DEPARTMENT OF TRANSPORTATION

Contract #: 04-0120F4Cty: SF/ALA Rte: 80 PM: 13.2/13.9File #: 69.25B**QUALITY ASSURANCE -- NON-CONFORMANCE REPORT****Location:** Changxing Island, Shanghai, PRC**Report No:** NCR-000438**Prime Contractor:** American Bridge/Fluor Enterprises, a JV**Date:** 28-Sep-2009**Submitting Contractor:** Zhenhua Port Machinery Company, Ltd (ZPMC), Changxing Island**NCR #:** ZPMC-0412**Type of problem:****Welding****Concrete****Other****Welding****Curing****Procedural****Bridge No:** 34-0006**Joint fit-up****Coating****Other****Component:** North Tower**Procedural****Procedural****Description:** North Tower, Lift 3, BC Diagonal Stiffener**Reference Description:** Free hand thermal cutting on North Tower, Lift 3, BC Diagonal Stiffener**Description of Non-Conformance:**

Subject: NCR No. ZPMC-0412

Job Name: SAS Superstructure

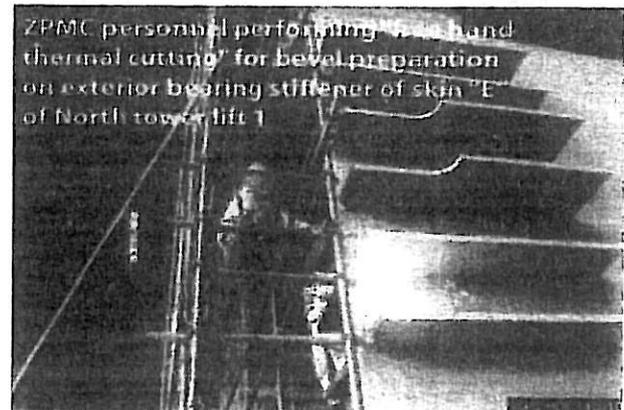
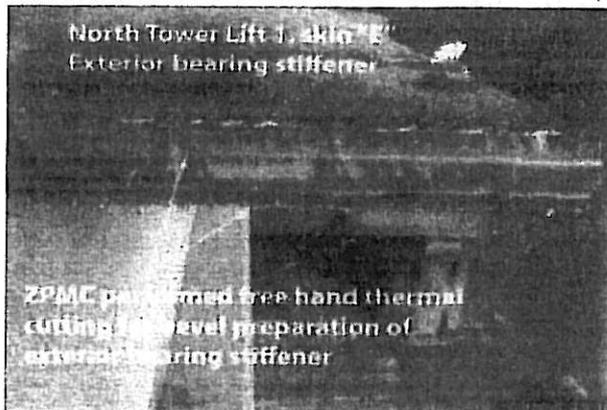
During Visual Testing (VT) of North Tower, Lift 1, Skin E exterior bearing stiffeners, QA observed 'free hand thermal cutting' for bevel preparation being carried out by ZPMC personnel without approval by the Engineer.

AWS D1.5-2002, Section 3.2.3 - "Steel and weld metal may be thermally cut, provided a smooth and regular surface free from cracks and notches is secured, and provided that an accurate profile is secured by the use of a mechanical guide. Freehand thermal cutting shall be done only where approved by the Engineer."

Reference Description: Unapproved freehand thermal cutting on North Tower, Lift 1

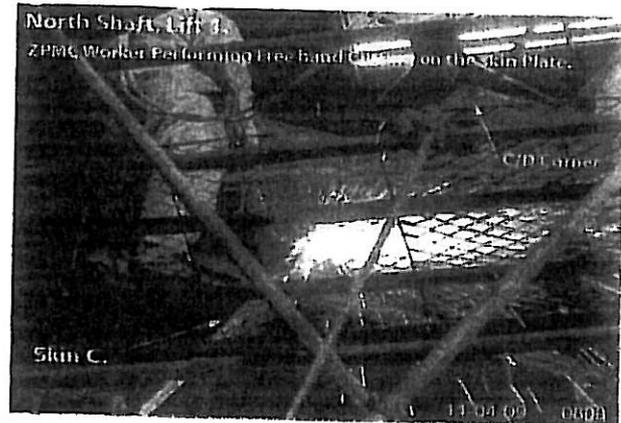
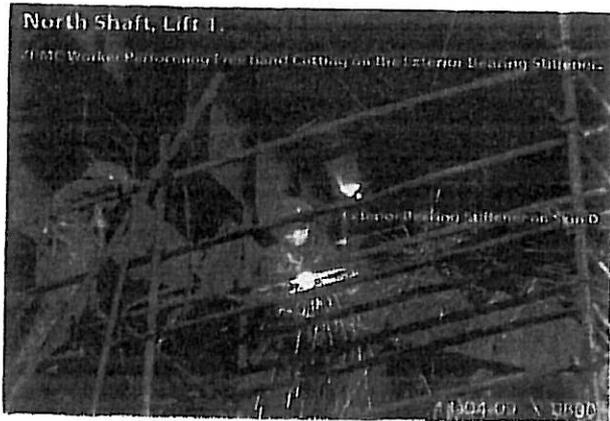
During Visual Testing (VT) of North Tower, Lift 1, exterior bearing stiffeners, QA observed 'freehand thermal cutting' being carried out by ZPMC personnel without Engineer approval.

AWS D1.5-2002, Section 3.2.3 - "Steel and weld metal may be thermally cut, provided a smooth and regular surface free from cracks and notches is secured, and provided that an accurate profile is secured by the use of a mechanical guide. Freehand thermal cutting shall be done only where approved by the Engineer."

Reference Description: Free hand thermal cutting on North Tower, Lift 3, BC Diagonal Stiffener

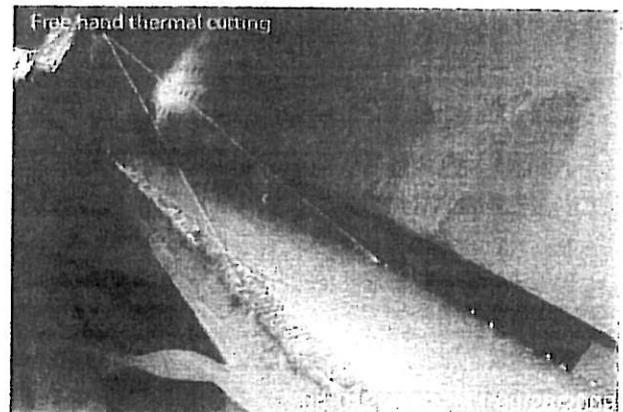
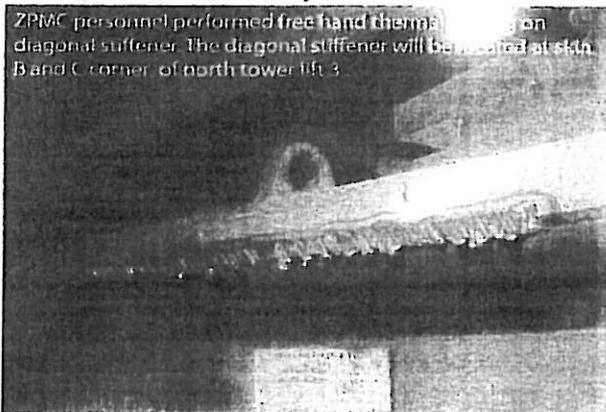
QA observed ZPMC personnel perform free hand thermal cutting on North Tower, Lift 3, BC Diagonal Stiffener, between the 85m and 89m Diaphragms. The length of the cut was approximately 850mm.

AWS D1.5-2002, Section 3.2.3 - "Steel and weld metal may be thermally cut, provided a smooth and regular surface free from cracks and notches is secured, and provided that an accurate profile is secured by the use of a mechanical guide. Freehand thermal cutting shall be done only where approved by the Engineer."

Reference Description: Unapproved freehand thermal cutting on West Tower base-end bevel preparation

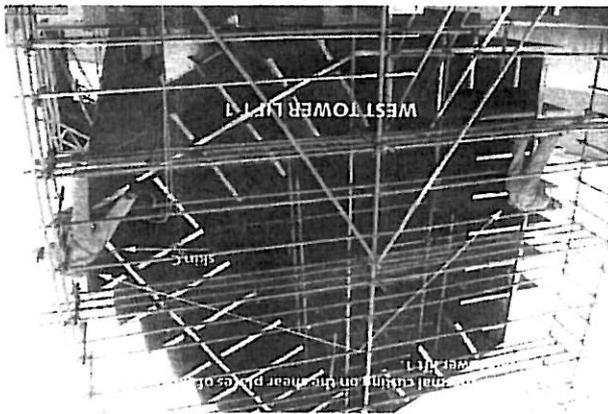
Description of Non-Conformance: During in-process Visual Testing (VT) of West Tower, Lift 1, base-end bevel preparation, QA observed 'freehand thermal cutting' being carried out by ZPMC personnel. Access to the areas being cut were not restricted due to cross sectional geometry and or position in so far as mechanical guides could not be used.

AWS D1.5-2002, Section 3.2.3 - "Steel and weld metal may be thermally cut, provided a smooth and regular surface free from cracks and notches is secured, and provided that an accurate profile is secured by the use of a mechanical guide. Freehand thermal cutting shall be done only where approved by the Engineer."
